Sundry Print Report

Well Name: POKER LAKE UNIT 18-19 Well Location: T25S / R30E / SEC 18 / County or Parish/State:

**Sundry ID: 2716471**

Type of Action: APD Change

WELL LOCATION AND ACREAGE DEDICATION PLAT

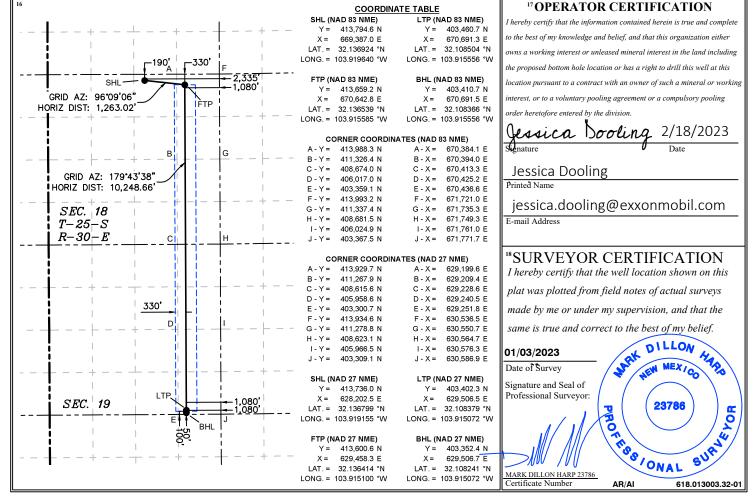
**Procedure Description:** \*\*Surface Location Move, Bottomhole Location Change, First and Last Take Point Changes XTO Permian Operating, LLC requests permission to make the following changes to the original APD: No Additional Surface Disturbance Change SHL fr/265'FNL & 1845'FEL to 190'FNL & 2335'FEL, Section 18-T25S-R30E Total SHL Move: 75'Notrh & 490'West SHL change requested to optimize well pad layout, drilling efficiencies, and for safety purposes. Change BHL fr/20'FSL & 746'FEL to 50'FSL & 1080'FEL, Section 19-T25S-R30E Change FTP fr/330'FNL & 746'FEL to 330'FNL & 1080'FEL Change LTP fr/100'FSL & 746'FEL to 100'FSL & 1080'FEL

UL or lot no.	Section	Township	Range	Lot Idn	Feet from the	North/South line	Feet from the	East/West line	County
В	18	25 S	30 E		190	NORTH	2,335	EAST	EDDY
			" Bott	om Hole	Location If	Different Fron	n Surface		
UL or lot no.	Section	Township	Range	Lot Idn	Feet from the	North/South line	Feet from the	East/West line	County
P	19	25 S	30 E		50	SOUTH	1,080	EAST	EDDY
